# PLANNING COMMISSION REGULAR MEETING

**AGENDA ITEM TITLE:** 1. Residences at Salida Bottling Company Planned Development; and  
2. Residences at Salida Bottling Company Major Subdivision

This request has been continued from the December 14<sup>th</sup> Planning Commission meeting in order to allow time for submittal and review of the civil plans. All new items in this report are highlighted in blue. The applicant (Salida Bottling Company, LLC) is requesting a Major Impact Review for two actions related to a 0.60 ac. (26,112 SF) parcel at 323 West First Street, at the west corner of Hwy 291 and the Monarch Spur Trail (see subject property outlined below). The property is described as “Part of Lots 4 & 5, All of Lots 6-9, Block 19” and is split zoned, with the majority (76%) zoned Commercial (C-1) and the portion along the Spur Trail/ abandoned D&RG right-of-way (24%) zoned Industrial (I). The entire site is located within the Hwy 291 Established Residential Overlay. The requests are:

**PROPOSED PD PLAN (slight balcony modifications):**

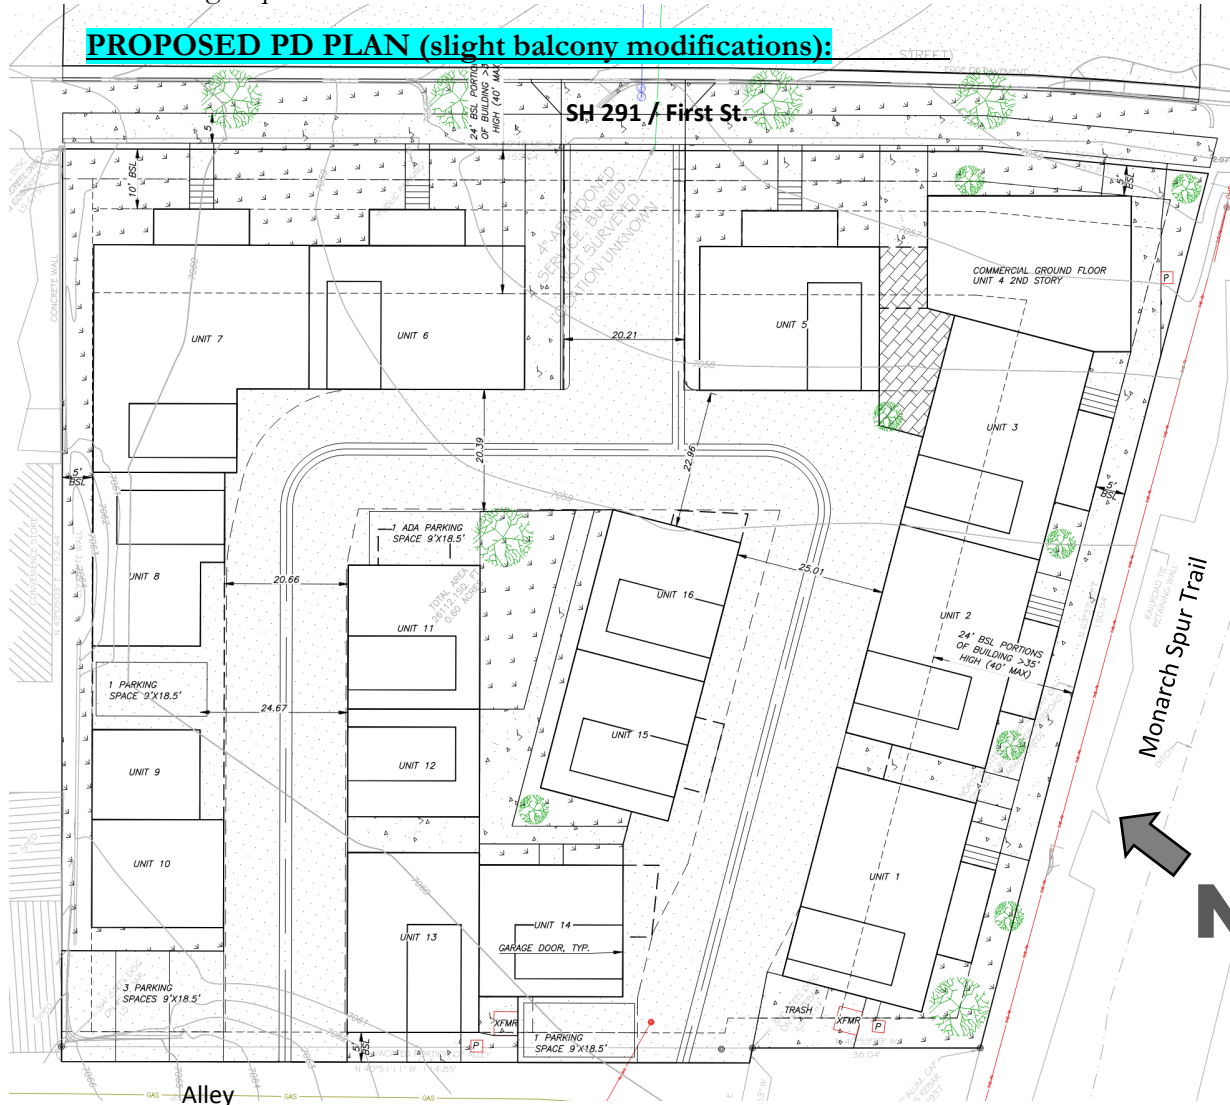
ownership of land and buildings.” This proposal is for clustered buildings with shared common walls, and will be platted for individual townhome ownership. To achieve the desired architectural character, the requested density, and to create zero-lot line townhome lots, a number of deviations are requested. These are detailed in the Planned Development Standards section of the report. For clarity, this report discusses deviation requests based on the C-1 zone only. The Dimensional Standards tables still contain the Industrial zoning requirements for reference.

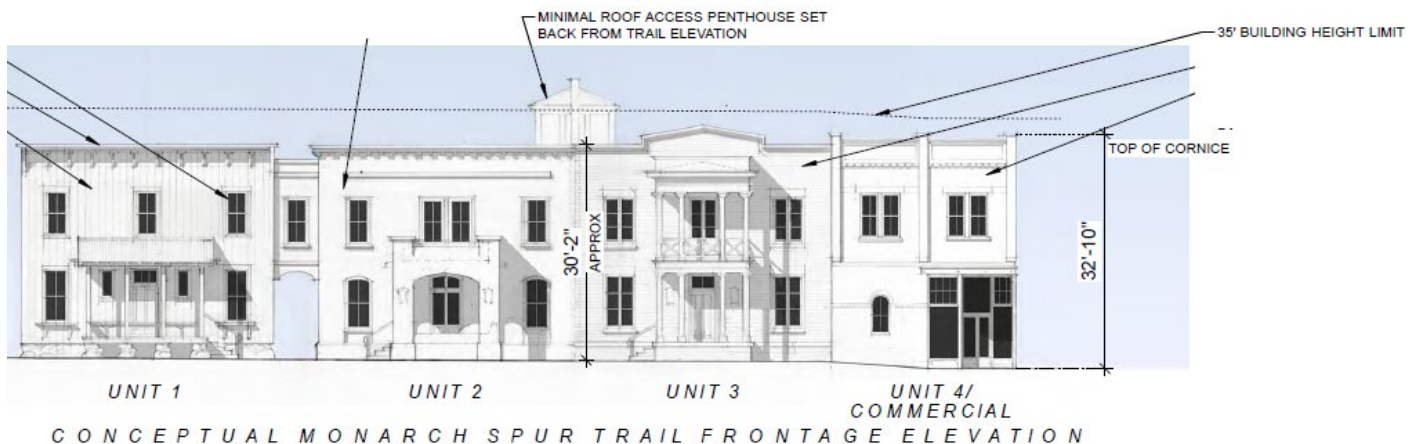
**Units 1-4** (illustrated below and in yellow on the site plan). Units 1-4 are proposed at the allowed 2 stories for the majority of the structures. A deviation is requested for the portions of Units 1-4 shown in yellow on page 8, in which the applicant is requesting the ability to locate a rooftop access

Staff recommends that the request be limited to the minimum necessary to allow rooftop access and only where it will not potentially obstruct prominent view corridors from downtown. Therefore staff recommends that rooftop access on Units 2 & 3 be allowed only as one combined structure at a total of 100 sf for the two units, and recommends that no rooftop access structure be allowed on Unit 4 due to the higher visibility of that location from downtown and the potential obstruction of prominent viewsheds. Unit 1 would be limited to a single, 100 sf maximum, rooftop access structure. The recommended condition of approval is:

- Units 1-3 are allowed a rooftop access structure that cannot exceed 40 feet in height at its highest point. It may be up to 100 square feet on Unit 1. Units 2 & 3 are allowed a shared rooftop access structure up to 150 square feet (in total, not per unit). Shared structure can be greater than 150 square feet only if required by the Building Official, and shall be limited to the minimum required square footage. No rooftop access structure is allowed on Unit 4.

*Concept of Unit 6 illustrating a portion at 2.5 story and a portion at 3 story*

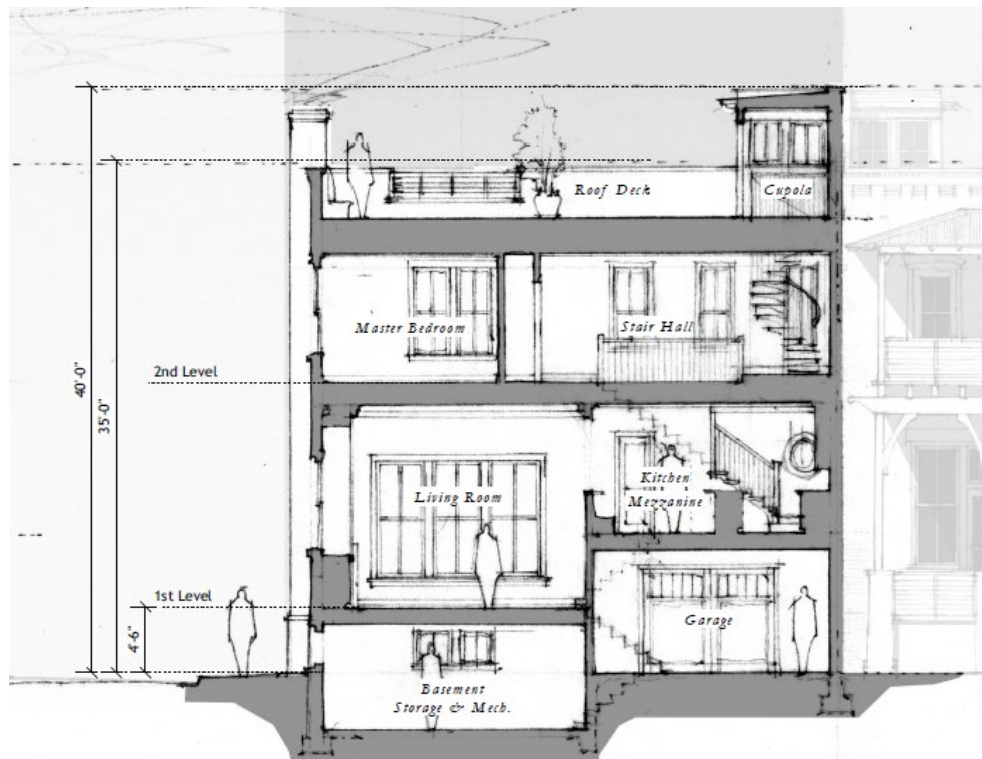
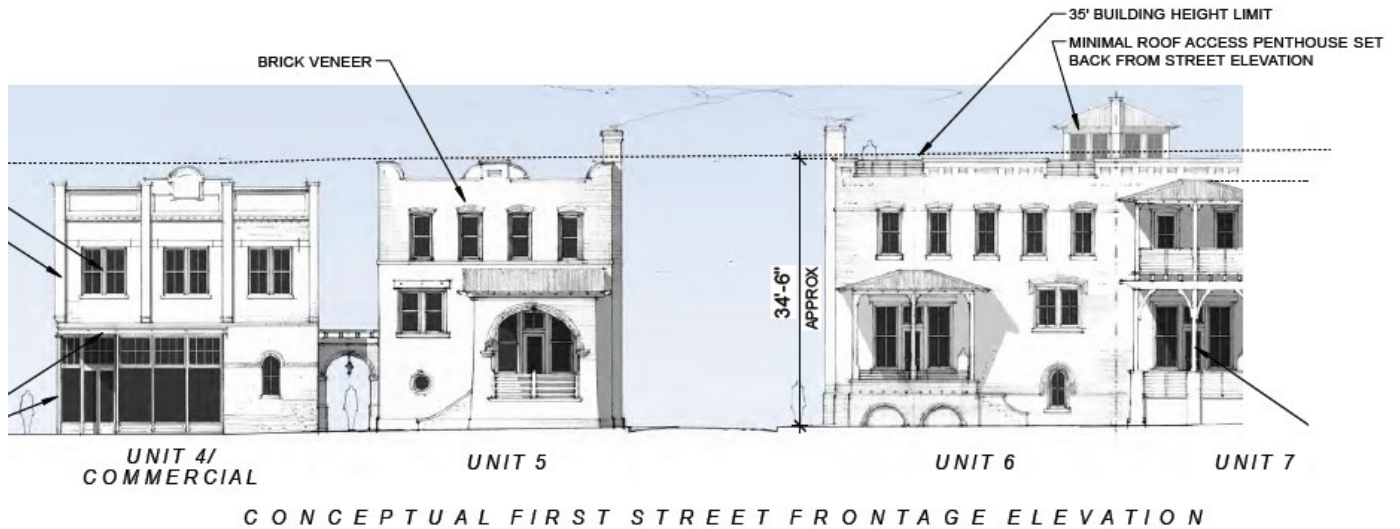
➤ **Units 5-7** (illustrated below and in blue on the site plan). The applicant is requesting a deviation to allow Units 5-7 to be 3 story buildings. The proposed maximum height of the 3 stories is 35 feet, which does not require a deviation. However, a deviation is requested to allow a rooftop access structure, limited to 100 sf per unit, to be a maximum of 40 feet at its highest point. Additionally, the applicant has requested an allowance for chimneys up to 40 feet.

- Units 5-7 can be a maximum of 3 stories and 35 feet in height with the exception of chimneys and a rooftop access structure on Units 6 & 7. Units 6 & 7 are allowed a shared rooftop access structure that cannot exceed 40 feet in height at its highest point, and can be up to 150 square feet (in total, not per unit). Shared structure can be greater than 150

square feet only if required by the Building Official, and shall be limited to the minimum required square footage. No rooftop access structure is allowed on Unit 5. Chimneys shall not exceed 40 feet.
